**Addendum No. 001**

**Subject: 2020 Classroom Modernizations**  
**SDP Contract Numbers: B-028 C of 19/20 & B-030 C of 19/20**

**Location: Overbrook Educational Center**  
**6722 Lansdowne Ave, Philadelphia PA 19151**

**This Addendum, dated March 6, 2020, shall modify and become part of the Contract Documents for the work of this project. Any items not mentioned herein, or affected by, shall be performed strictly in accordance with the original documents.**

1 OVERALL THIRD FLOOR DEMOLITION PLAN  
D1.3 1/8" = 1'-0"

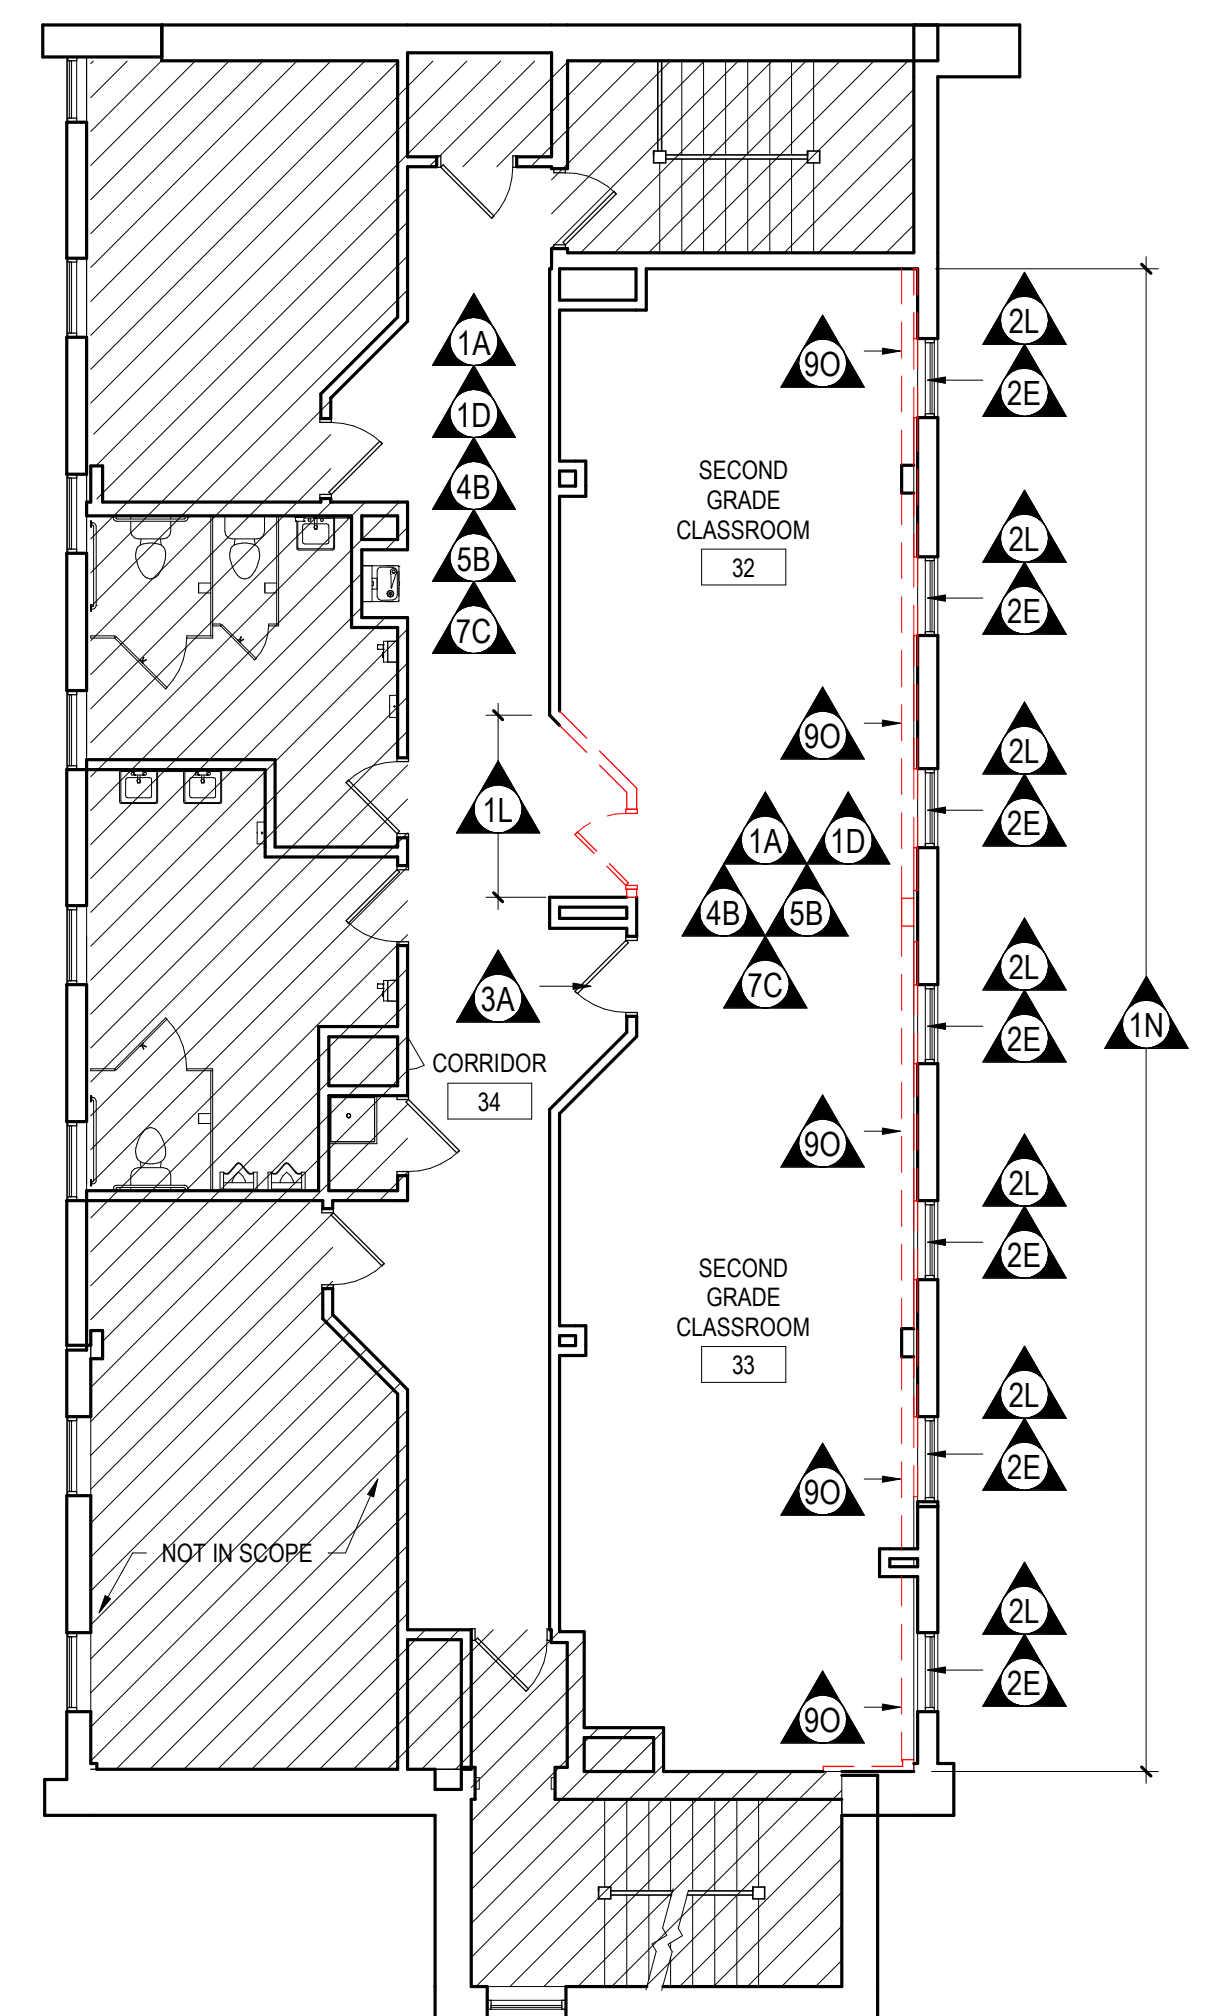
1. REVISED demolition note 9N as indicated on drawings.

LOCATION NO.	FILE NO.
DRAWN BY	CHECKED BY
B-028C OF 2019 / 20	B-030C OF 2019 / 20
DRAWING NO. <b>A1.1</b>

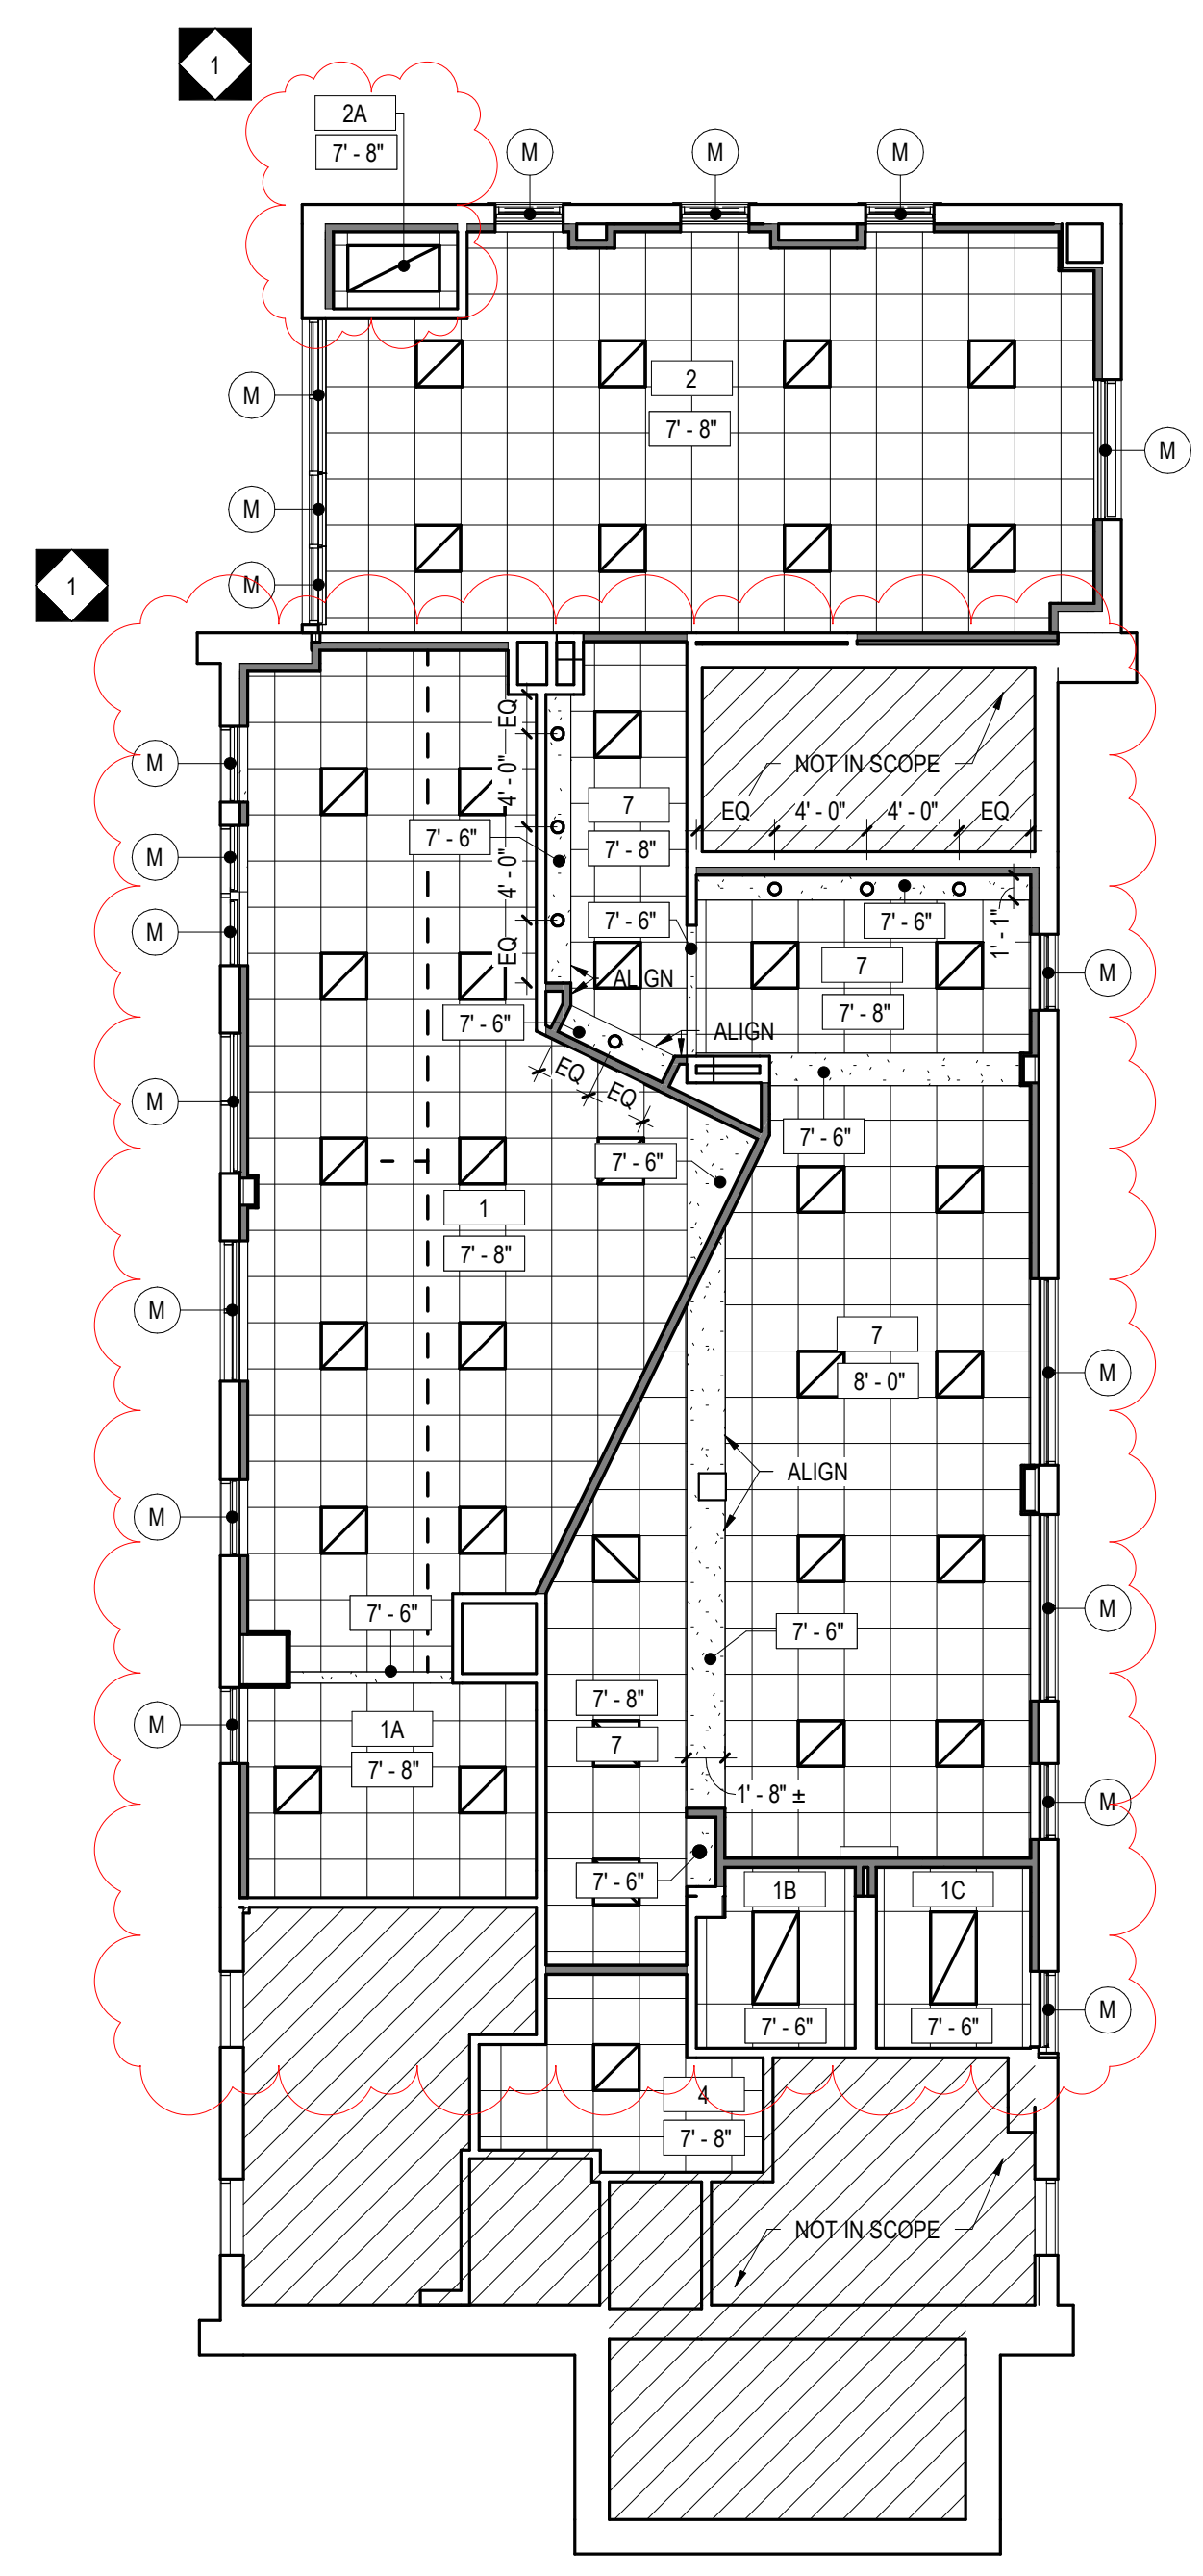
1. REVISE plan 1/A1.1 to remove Special Education Office #3 and relocate to/replace former Work Room #6 as indicated on the drawings.
2. REVISE “Cubbie Alcove-1A” to read “Alcove-1A”.
3. REMOVE “box-out” stud walls in Alcove-1A.

LOCATION NO.	FILE NO.
DRAWN BY	CHECKED BY
B-028C	OF 2019 / 20
B-030C	OF 2019 / 20
DRAWING NO.	
<b>A2.1</b>

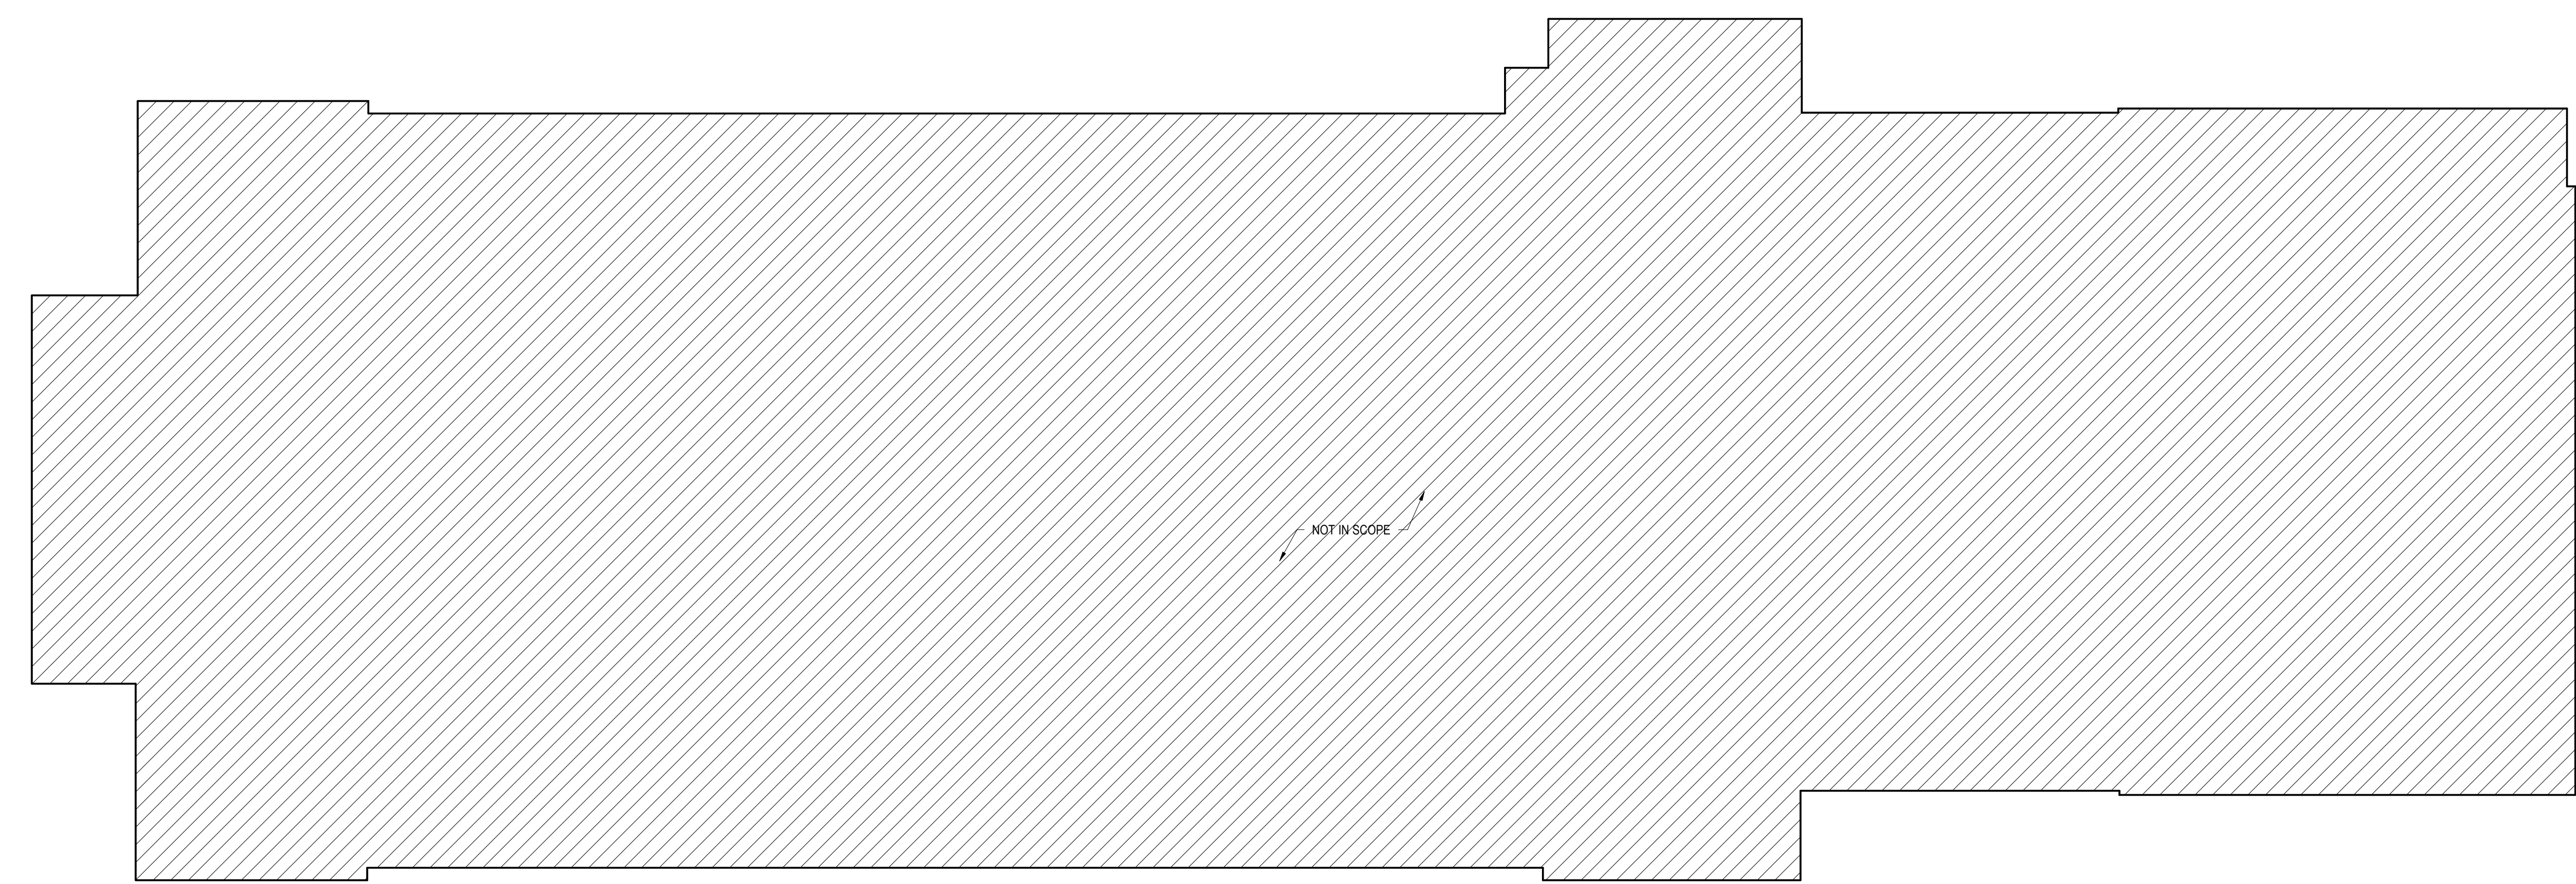
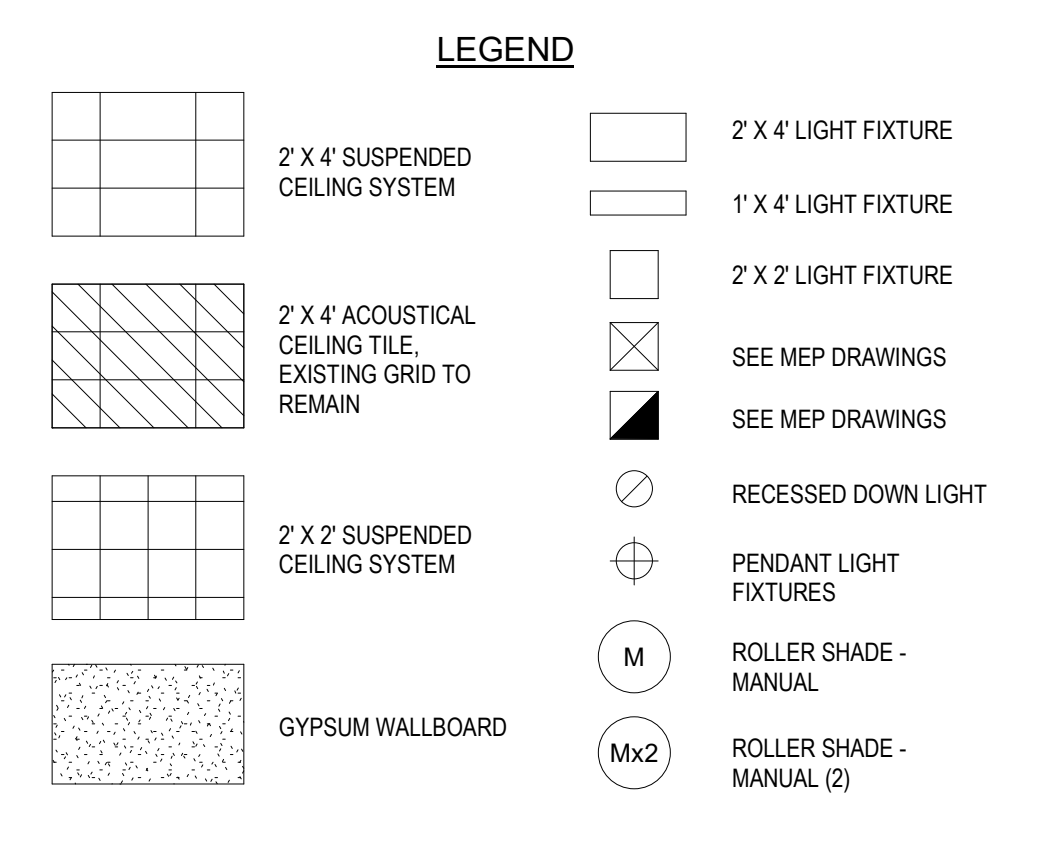
1. REVISE RCP 1/A2.1 to remove Special Education Office #3 and associated revisions as indicated on the drawings.
2. REVISE RCP 1/A2.1 to add a new ceiling to Closet-2A as indicated on the drawings.
3. REVISE 2x4 ceiling grid and tile system to be 2x2 ceiling grid and tile system in rooms 1, 1A, 2, 4, and 7.
4. ADD GWB bulkheads over new cubbie locations in Small Group Instruction-7 and adjoining corridors as indicated on drawings.
